ARGO 300 (Export)... Cont....

VIEWED AT THE PCB

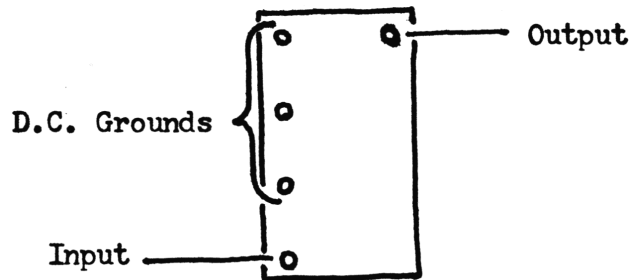
REJECTION: ??, this unit definitely needs some work done in this area. Use SCB Vol-19, Pg. 61 as a how-to guide. Remove FL-2 and replace per diagram below:
